UNITED STATES PATENT AND TRADEMARK OFFICE

Office Action Summary

10/616,707

FANOUS, REFAAT S.

Figure 1

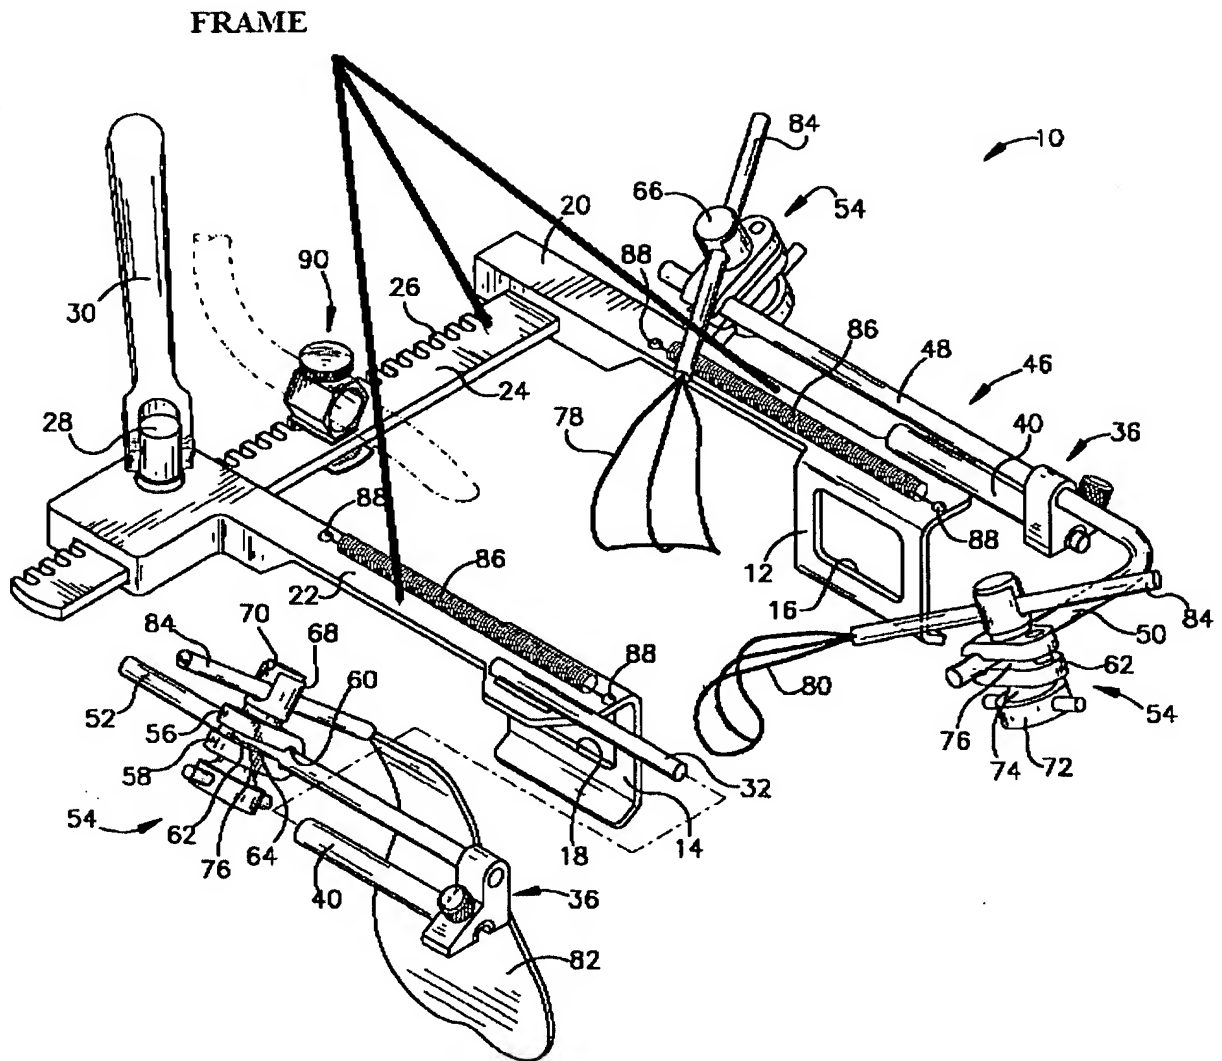
Claims 1-3, 11, 14, 16, 18, 23, 31, 33 and 37 are rejected, as understood, under 35 U.S.C. 102(b) as being anticipated by Santilli et al. (U.S. Patent No. 6,099,468).

Santilli et al. discloses a retraction device (10) comprising a frame (see Figure 1 below) hinged (28) on a handle (30), where the frame includes a track (50) and a least one or more anterior retractors with a curved blade (78, 80, 82), attached to the retractor-handle (84) that is attached to the frame with a jig (54), where the retractor (10) is slidably mounted on the track (50) by a jig that does not contact the patient; a ratchet mechanism (26); and a support element (90) attached to the handle for retaining the device in a position .

Figure 2

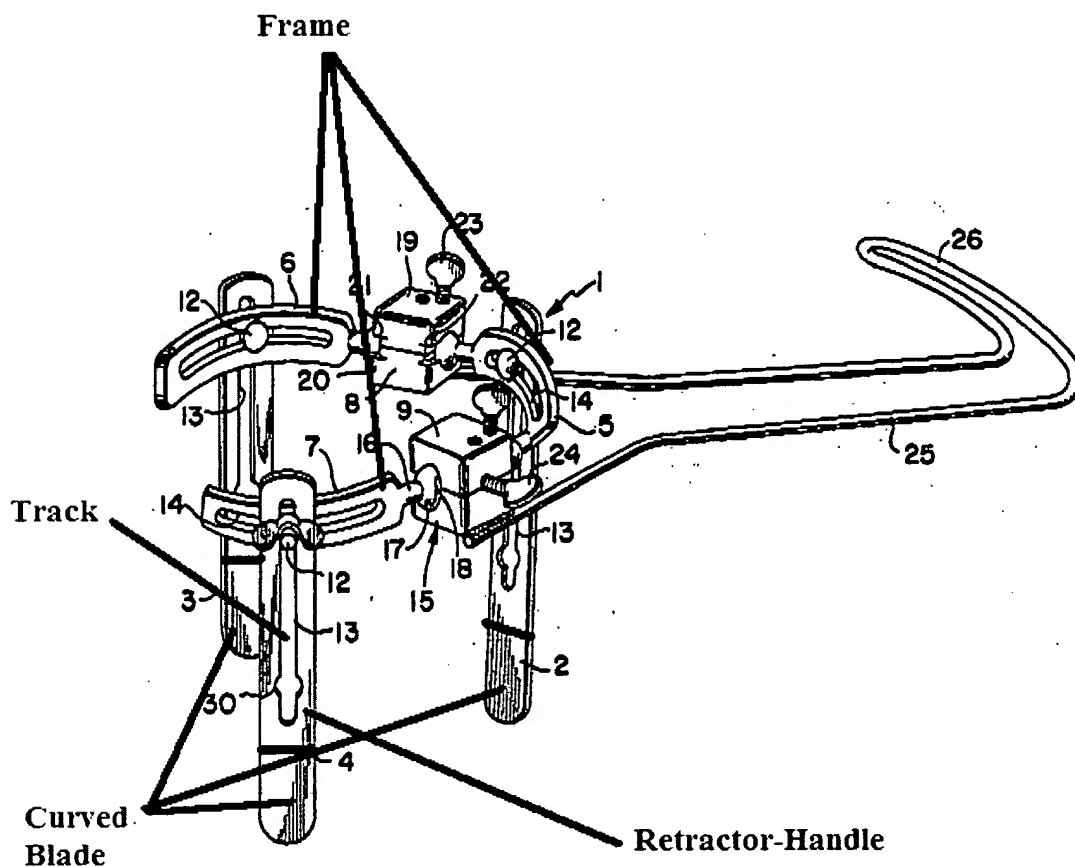
Claims 1, 3, 9, 11, 14, 16, 18, 20, 23, 31-34 and 40 are rejected, as understood, under 35 U.S.C. 102(b) as being anticipated by Karlin et al. (U.S. Patent No. 3,509,873).

Karlin et al. discloses a retraction device (1) comprising a frame (see Figure 2 below) hinged (18) on a handle (25), where the frame includes a track (see Figure 2) and a least one or more anterior retractors with a curved blade (see Figure 2), attached

to the retractor-handle (see Figure 2) that is attached to the frame with a jig (12), where the retractor is slidably mounted on the track by a jig that does not contact the patient; the track includes a groove/slot (14) for slidably mounting the jig (12) to the track; a support element (9) attached to the handle (25); a retractor-handle that has a groove along a portion of a length of it, where the groove (14) has a differential width (30); and the retractor is configured with a curved blade forming a groove capable of supporting another blade.
